Project	IEEE 802.16 Broadband Wireless Access Working Group <http://ieee802.org/16>
Title	Proposed text and ASN.1 code to support PKMV1 and PKMV2
Date Submitted	2007-01-18
Source(s)	Joey Chou Intel Corporation [mailto:joey.chou@intel.com]

Abstract	This contribution proposes the text and ASN.1 code in wmanIf2Mib to support PKMV1 and PKMV2.
Purpose	Adoption
Notice	This document has been prepared to assist IEEE 802.16. It is offered as a basis for discussion and is not binding on the contributing individual(s) or organization(s). The material in this document is subject to change in form and content after further study. The contributor(s) reserve(s) the right to add, amend or withdraw material contained herein.
Release	The contributor grants a free, irrevocable license to the IEEE to incorporate material contained in this contribution, and any modifications thereof, in the creation of an IEEE Standards publication; to copyright in the IEEE's name any IEEE Standards publication even though it may include portions of this contribution; and at the IEEE's sole discretion to permit others to reproduce in whole or in part the resulting IEEE Standards publication. The contributor also ackno

12
13
14
15
Figure 8—wmanIf2BsPkmObjects structure

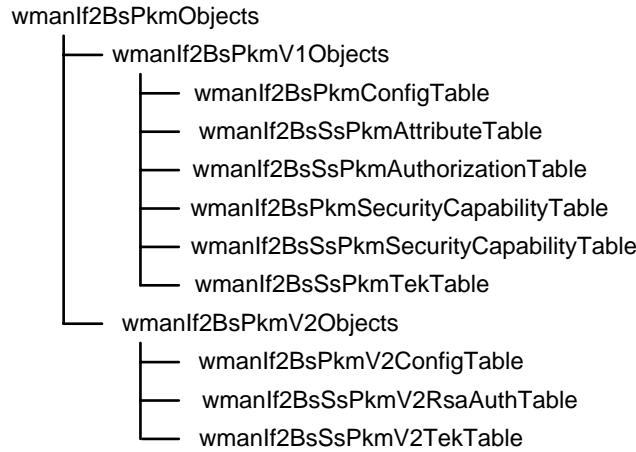
7 [Replace Subclause 13.1.3.1.3 as the following:]

10 Figure 8 shows the structure of wmanIf2BsPkmObjects subtree that contains BS managed objects
11 related to the MAC privacy management entity.

Figure 12— wmanIf2SsPkmObjects structure

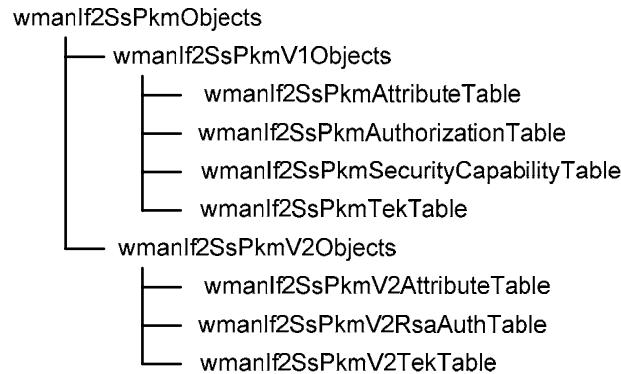
3 [Replace Subclause 13.1.3.2.2 as the following:]

6 Figure 12 shows the structure of wmanIf2SsPkmObjects subtree that contains subscriber station
7 manageable objects related to the privacy management entity.
